AGENDA
PLANNING BOARD
MEETING TIME 7:00 PM - MAIN MEETING ROOM
JANUARY 7, 2026

9.I. #2025-206 – Christian Brothers Academy, 850 Newman Springs Road, Block 1063, Lot 67.01, Located In The R-220 Zone.

Re: Varsity Gymnasium Air Conditioning
Christian Brothers Academy
850 Newman Springs Road
Block 1063, Lot 67.01
Minor Site Plan
First Engineering Review

EXTERIOR PAD / HVAC UNIT LOCATION PLAN

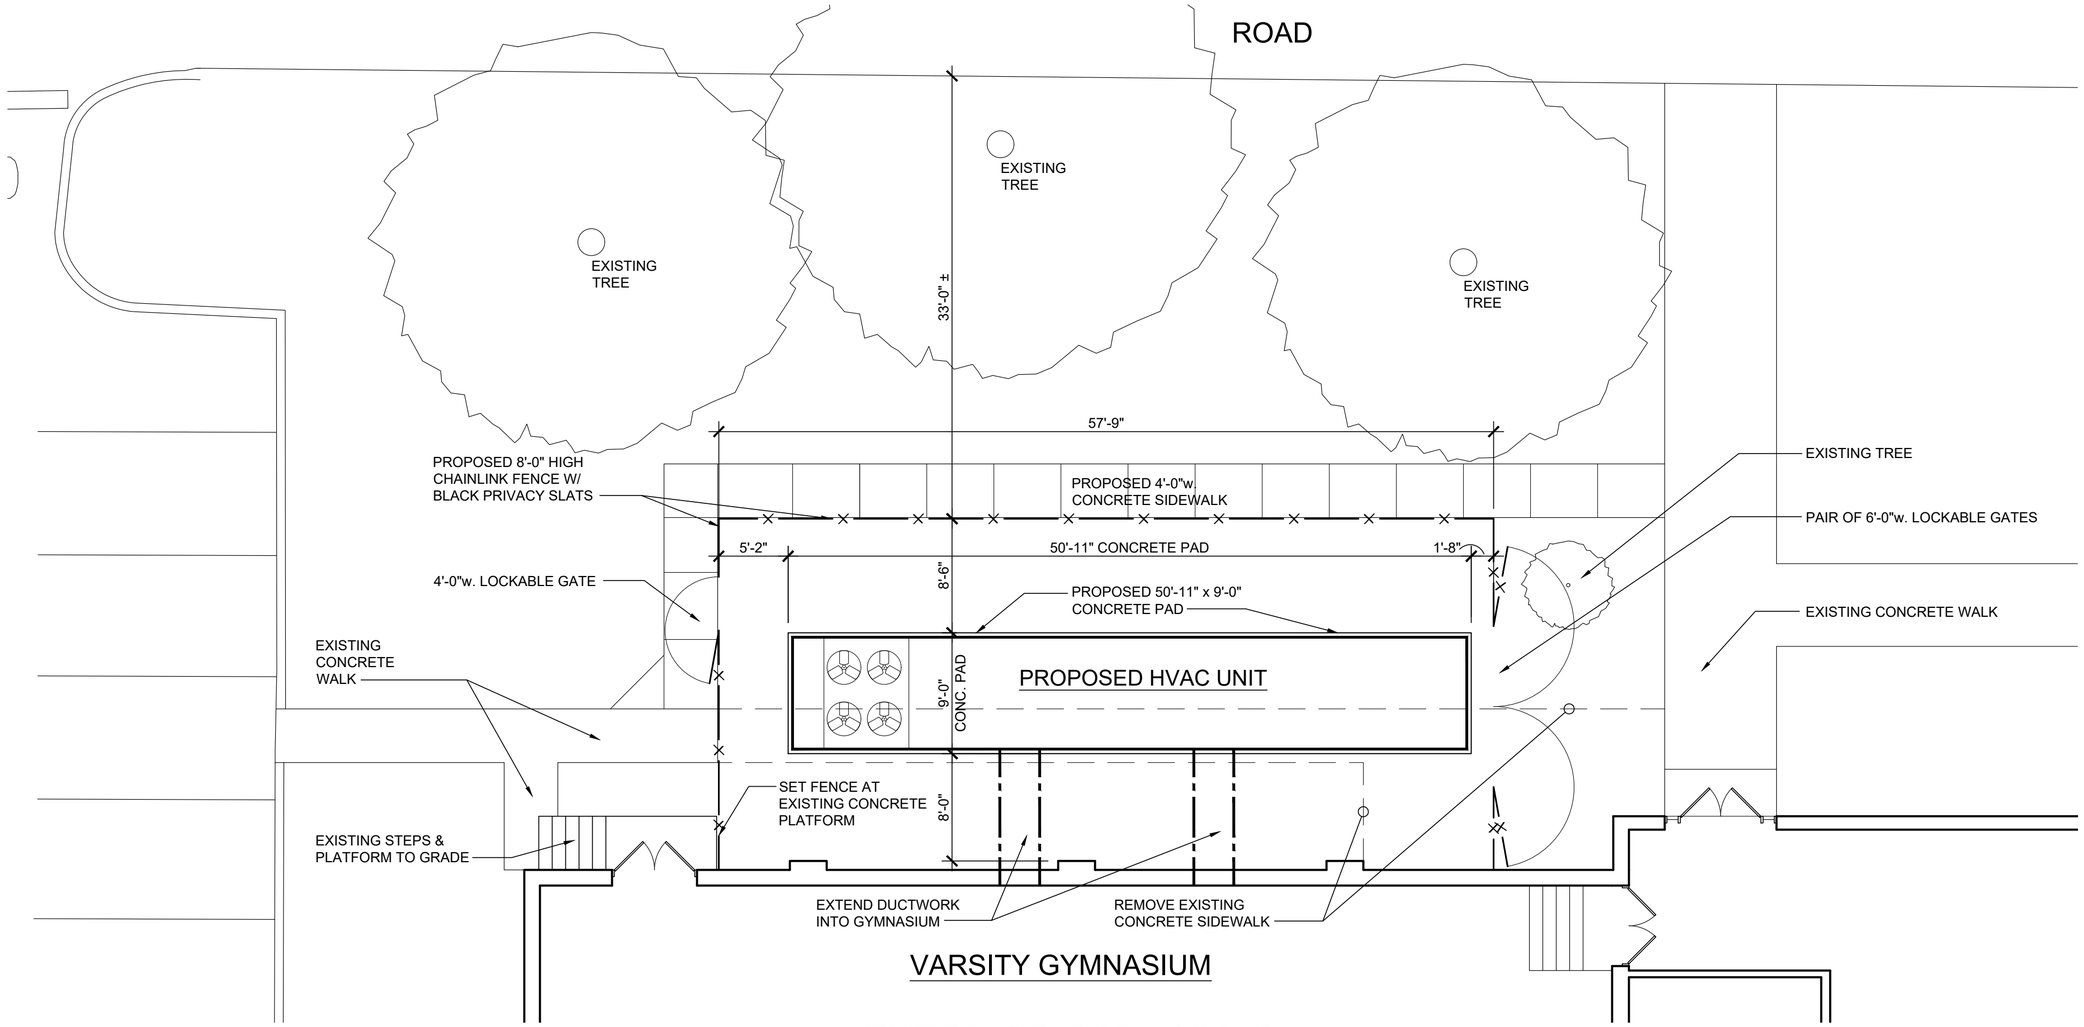
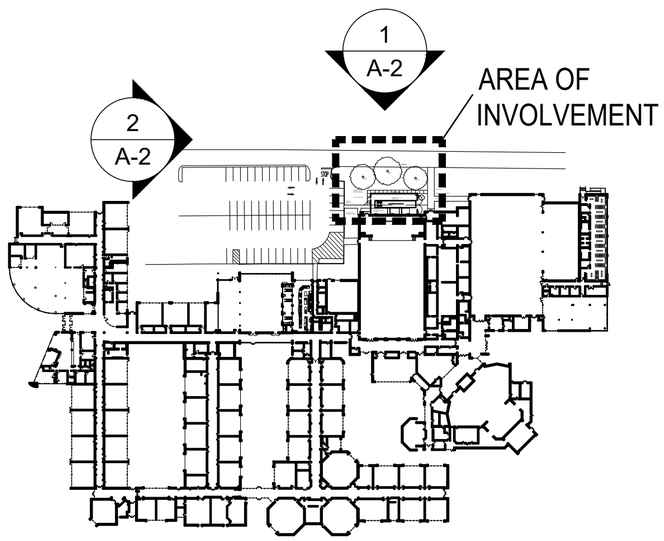
1. The applicant should clarify the height of the proposed HVAC unit. We note that as the unit is to be screened by an 8'-0" high chain link fence with privacy slats and the architectural elevation views indicate the unit will be slightly taller than the fence.

2. A construction detail shall be provided for the proposed fence.

4. Per Section 540-632.A.(1). of the Township Ordinance, screening of the HVAC unit shall consist of densely planted evergreen shrubs which shall grow to not less than five feet tall after one growing season. Currently no evergreen trees are proposed. The applicant shall provide the required screening or a design waiver will be required.
